E/ECE/324
E/ECE/TRANS/505 } Rev.1/Add.16/Rev.3/Amend.3

Addendum 16: Regulation No. 17

Revision 3 - Amendment 3

UNIFORM PROVISIONS CONCERNING THE APPROVAL OF VEHICLES WITH REGARD TO THE SEATS, THEIR ANCHORAGES AND ANY HEAD RESTRAINTS

Figure 1: Positions of test blocks before test of rear seat backs

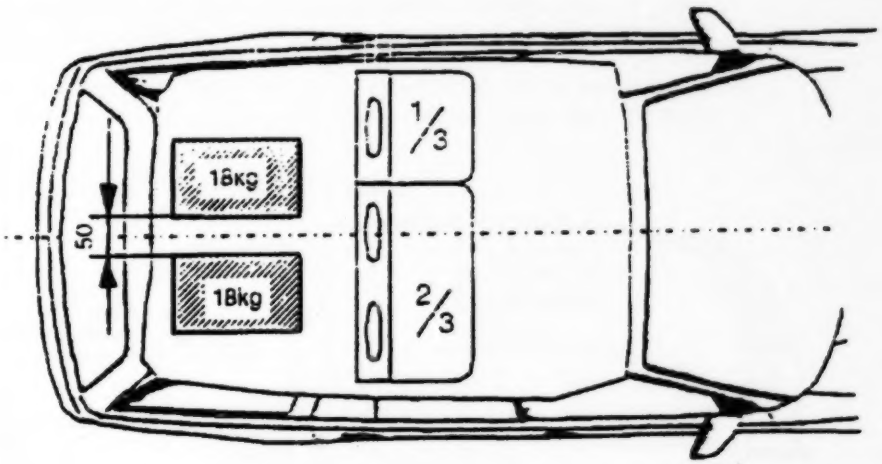
2.1. Test of seat backs (see figure 1)

2.1.1.1. Two type 1 test blocks shall be placed on the floor of the luggage compartment. In order to determine the location of the test blocks in the longitudinal direction, they shall first be positioned such that their front side contacts that part of the vehicle which constitutes the forward boundary of the luggage compartment and that their lower side rests on the floor of the luggage compartment. They shall then be moved backwards and parallel to the longitudinal median plane of the vehicle until their geometrical centre has traversed a horizontal distance of 200 mm. If the dimensions of the luggage compartment do not allow a distance of 200 mm and if the rear seats are horizontally adjustable, these seats shall be moved forward to the limit of the adjustment range intended for normal occupant use, or to the position resulting in a distance of 200 mm, whichever is less. In other cases, the test blocks shall be placed as far as possible behind the rear seats. The distance between the longitudinal median plane of the vehicle and the inward facing side of each test block shall be 25 mm to obtain a distance of 50 mm between both blocks.

2.1.1.2. During the test, the seats must be adjusted to ensure that the locking system cannot be released by external factors. If applicable, the seats shall be adjusted as follows:

The longitudinal adjustment shall be secured one notch or 10 mm in front of the rearmost possible position of use specified by the manufacturer (for seats with independent vertical adjustment, the cushion shall be placed to its lowest possible position). The test shall be carried out with the seat backs in their normal position of use.

2.1.1.3. If the seat back is fitted with a headrest, the test must be carried out with the headrest placed in the highest position, if adjustable.

2.1.1.4. If the back(s) of the rear seat(s) can be folded down, they shall be secured in their upright normal position by the standard locking mechanism.

2.1.1.5. Seats behind which the type 1 blocks cannot be installed are exempted from this test

Figure 2: Testing of a partitioning system above the backrest

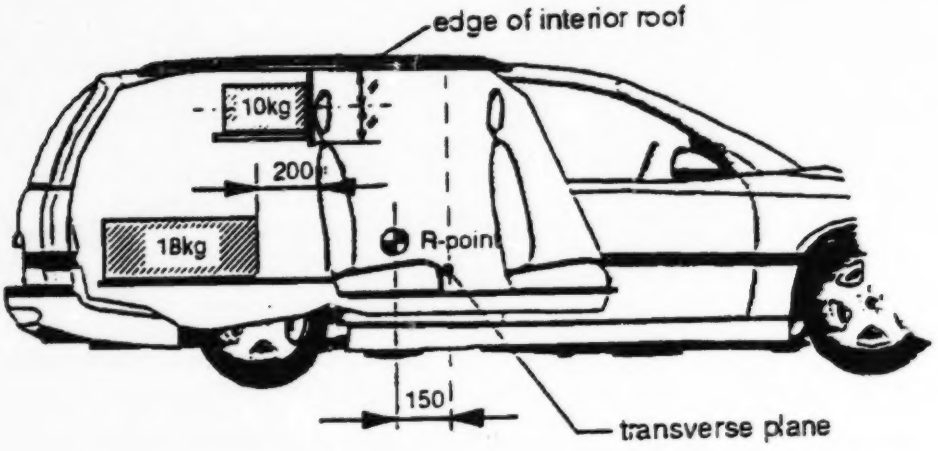
2.2. Test of partitioning systems

For the test of the partitioning systems above the seat backs, the vehicle shall be fitted with a fixed raised test floor having a load surface that locates the centre of gravity of the test block centrally between the top edge of the bordering seat back (without taking into account the headrests) and the bottom edge of the roof lining. A type 2 test block is placed on the raised test floor with its largest surface 500 x 350 mm, centrally in relation to the longitudinal axis of the vehicle and with its surface 500 x 125 mm to the front. Partitioning systems behind which the type 2 test block cannot be installed are exempted from this test. The test block is placed directly in contact with the partitioning system. In addition, two type 1 test blocks are positioned in accordance with paragraph 2.1. in order to perform a simultaneous test on the seat backs (see figure 2).

2.2.1. If the seat back is fitted with a headrest, the test must be carried out with the headrest placed in the highest position, if adjustable.

SLED DECELERATION CORRIDOR AS A FUNCTION OF TIME
(Frontal impact)

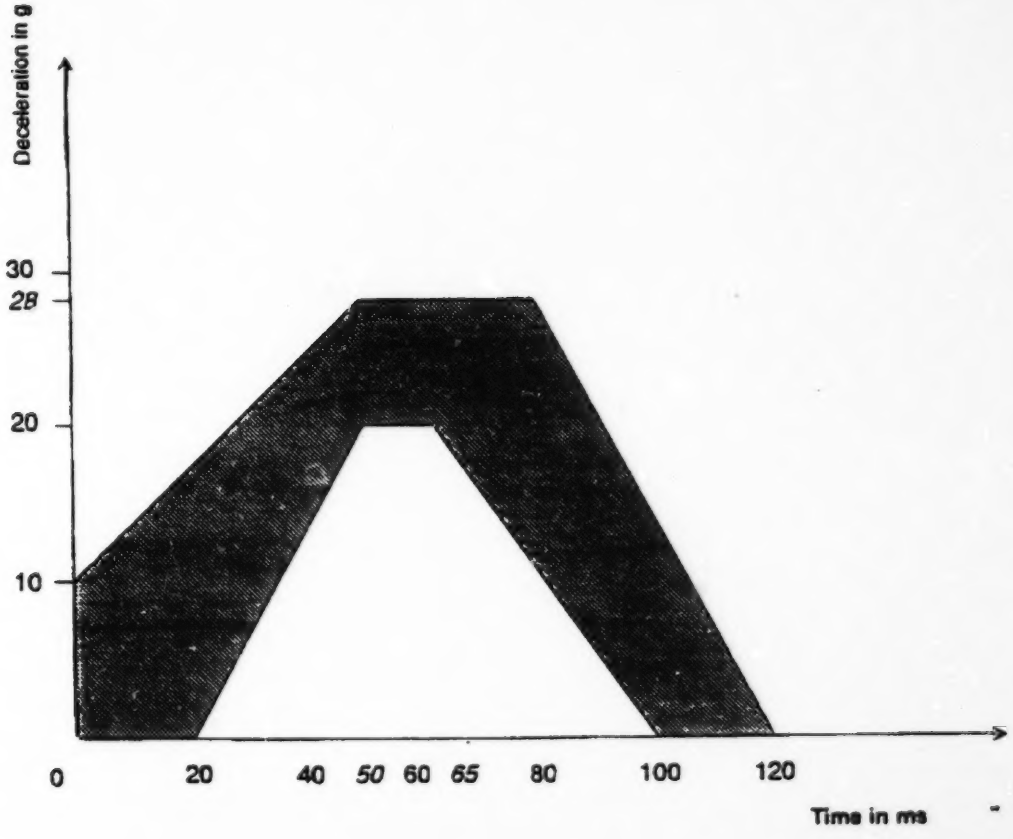
3.1. The body of the passenger car shall be anchored securely to a test sled, and this anchorage shall not act as reinforcement for seat backs and the partitioning system. After the installation of the test blocks as described in paragraph 2.1. or 2.2., the passenger

car body shall be accelerated as shown in annex 9, appendix. With the agreement of the manufacturer, the above described test pulse corridor can be used alternatively to fulfil the test of the seat strength according to paragraph 6.3.1."
